Re: Responses to "Proposed Revisions to the Acceptance Criteria for Steel Deck Roof and Floor Systems, Subject AC43-210-R1 (DM/WM)"

SUBJECT: Proposed Revisions to Acceptance Criteria for Steel Roof Deck and Floor Systems,
Subject AC430210-R1

ICC-ES AC43 Hearing

SUBJECT: Proposed Revisions to the Acceptance Criteria for Steel Deck Roof and Floor Systems, Subject AC43-0210-R1 (DM/WM)

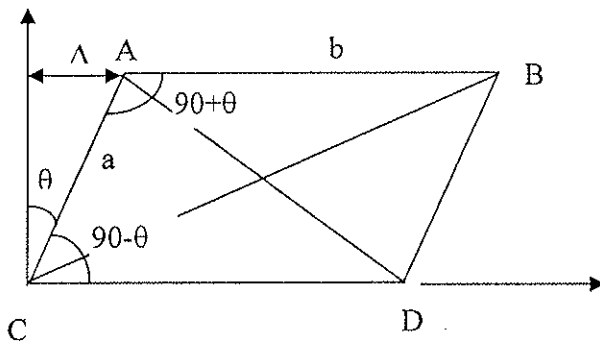
e. The diaphragm net deflection Equation 2 in AC43 does not match Equation 2 in AISI S907. The question is, "Which equation is correct?" ICC-ES believes that the equation in AC43 is the

correct and is a conservative approach. The industry is requested to provide information that establishes the correct equation.

The one above is from AC43. The one below is from AISI S907-08

The following derivation is provided which supports (Eq.-2)

In the figure above

$\Delta = a \sin \theta$ This is the deflection that we are interested.

Since $a \sin \theta$ is much smaller in quantity as compared to $a^2 + b^2$, the denominator can be approximated to $2\sqrt{a^2 + b^2}$

$$\Delta = (|\Delta_{BC}| + |\Delta_{AD}|) \frac{\sqrt{a^2 + b^2}}{2b}$$
